ADDENDUM NO. 3

May 3, 2022

YOST ELEMENTARY SCHOOL ADDITIONS AND RENOVATIONS
Chesterton, IN 46304

Addendum Three (AD.03) to the drawings and specifications prepared by Gibraltar Design for **New Newton Yost Elementary School** for Duneland School Corporation, Chesterton, Indiana.

1 EP104 UNIT "D" ELECTRICAL POWER FIRST FLOOR PLAN

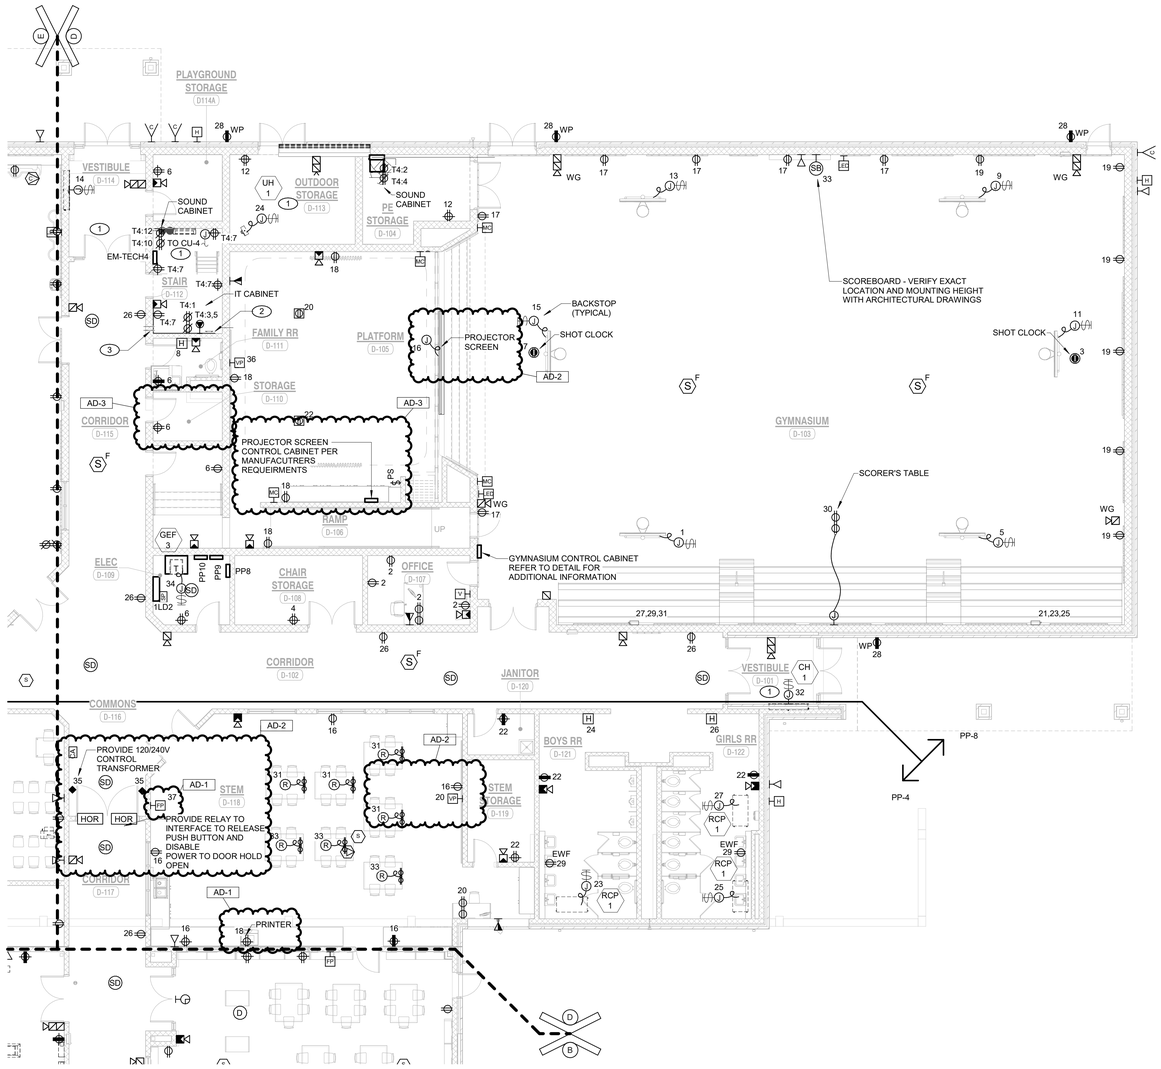
95. Sheet EP-104

1 EP201 OVERALL ELECTRICAL POWER ROOF PLAN

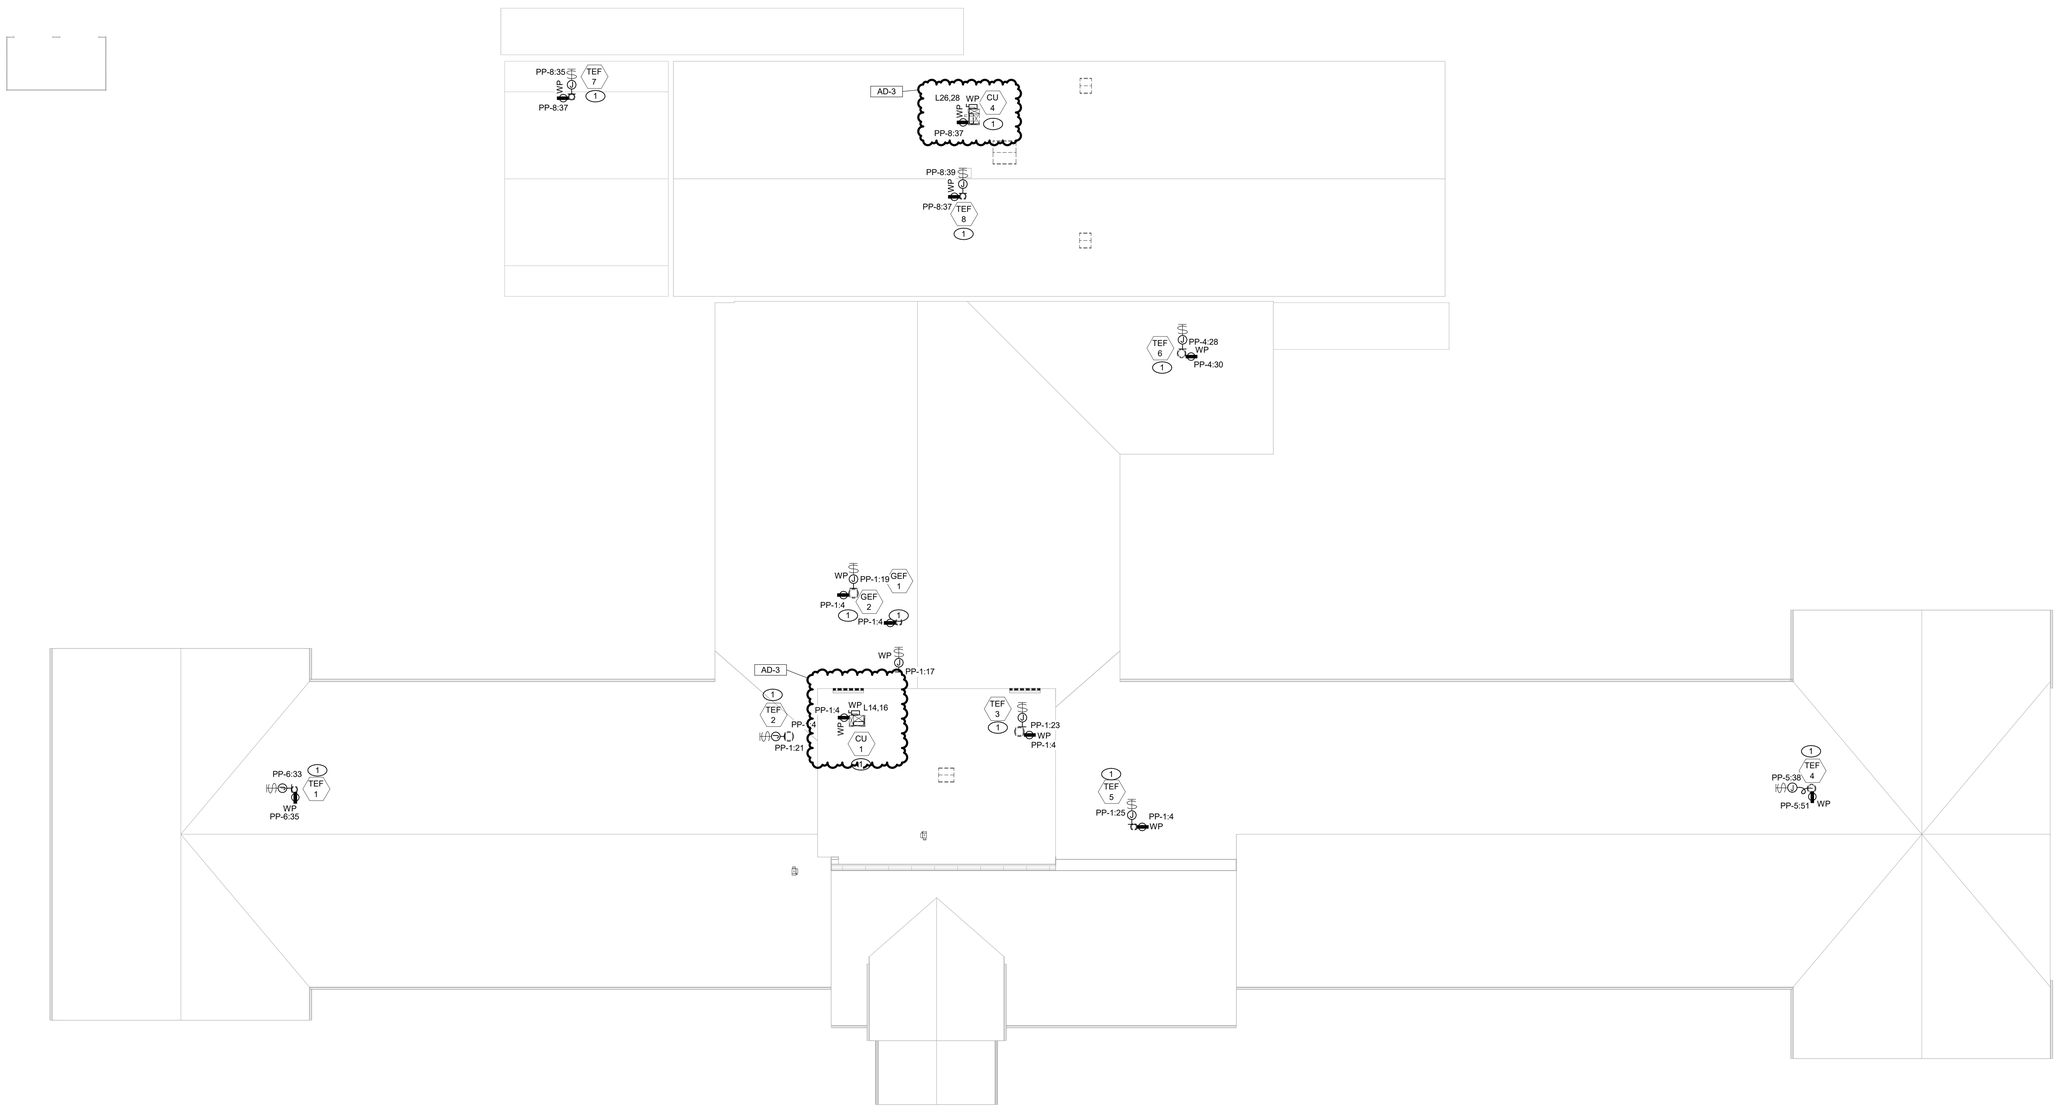
96. Sheet EP-201

1 Telecom First Floor Unit B
1/8" = 1'-0"

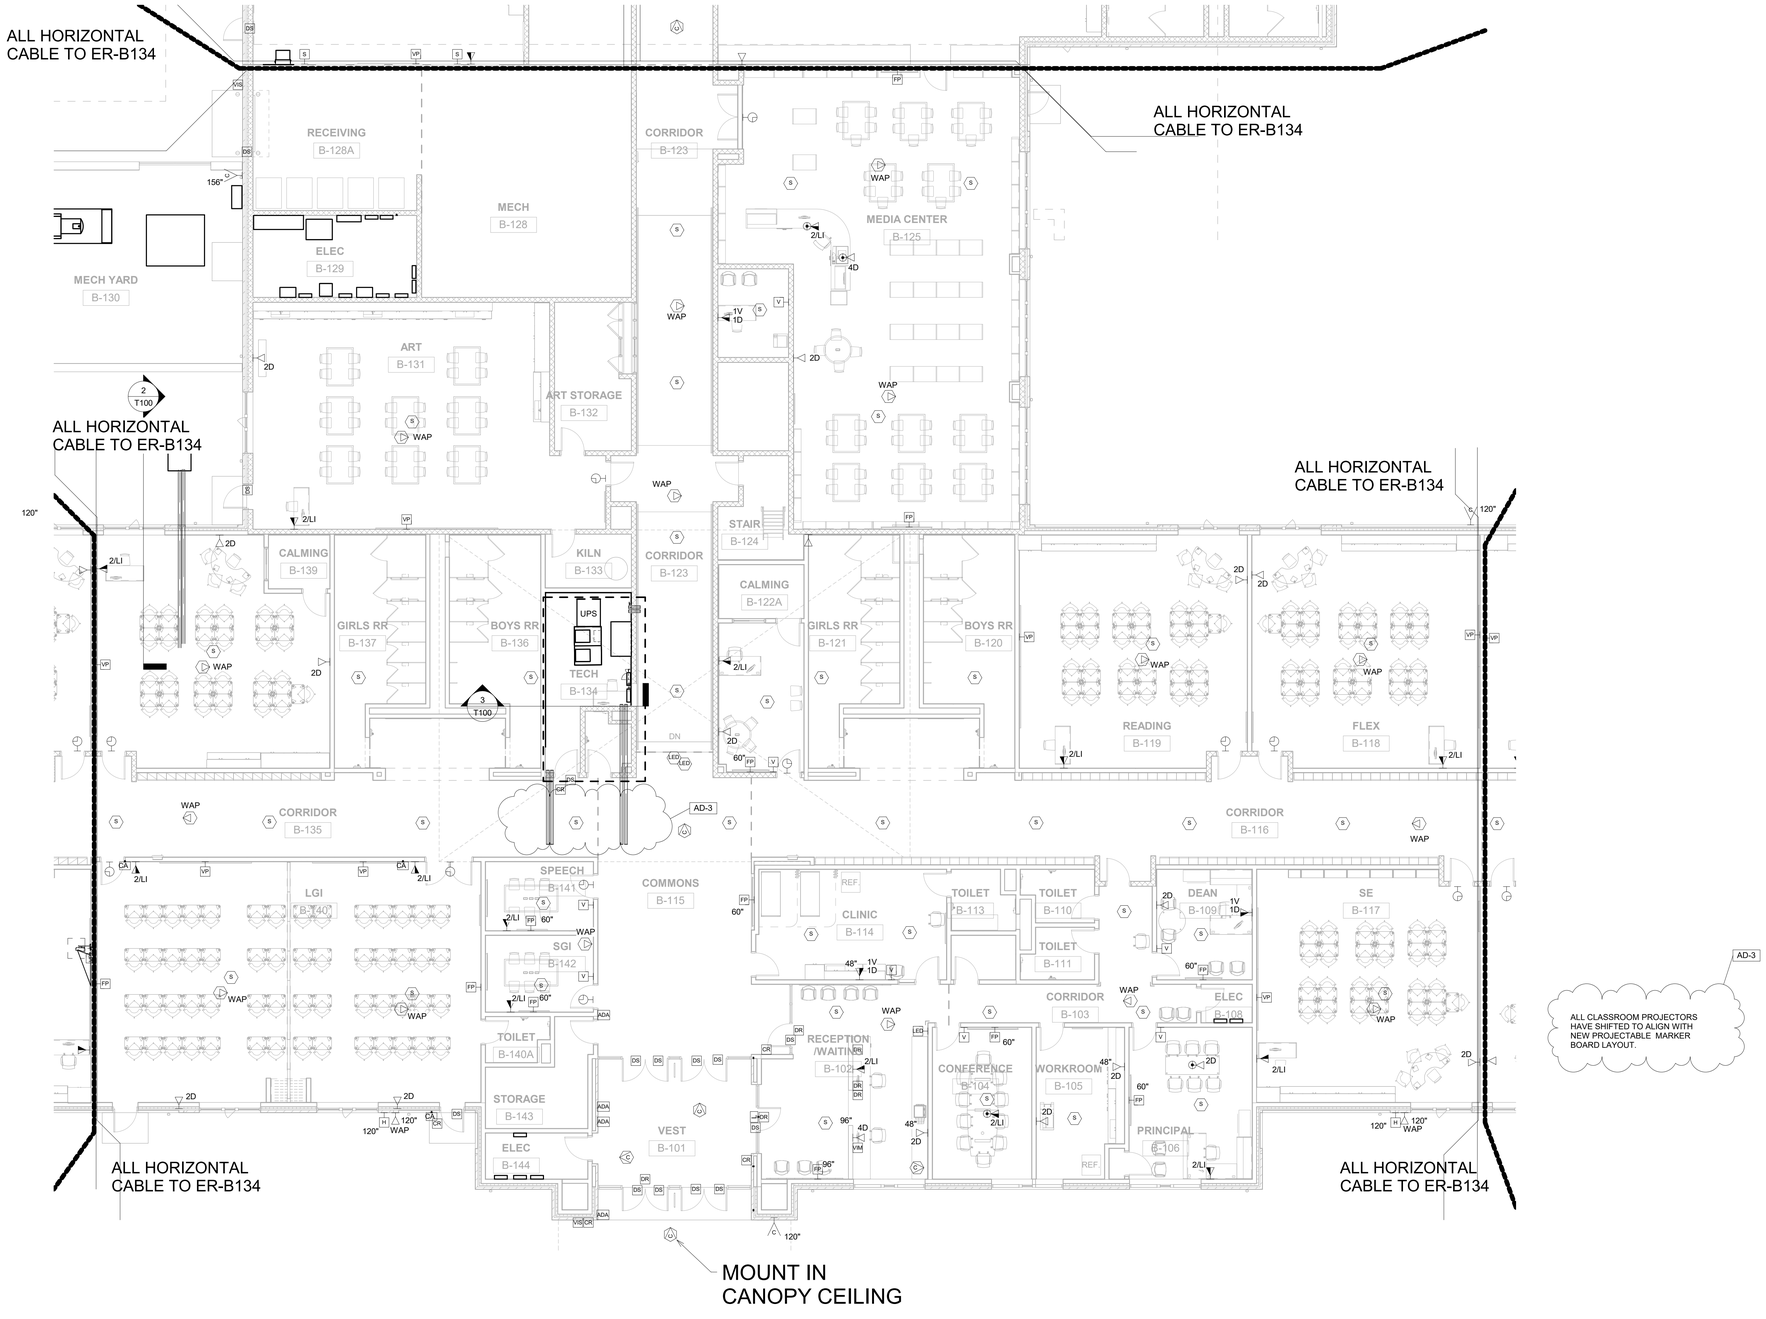
105.Sheet T-102

1. Sheet Note added: Extended conduit sleeves to cable tray proximity (also noted on Sheet T-100)
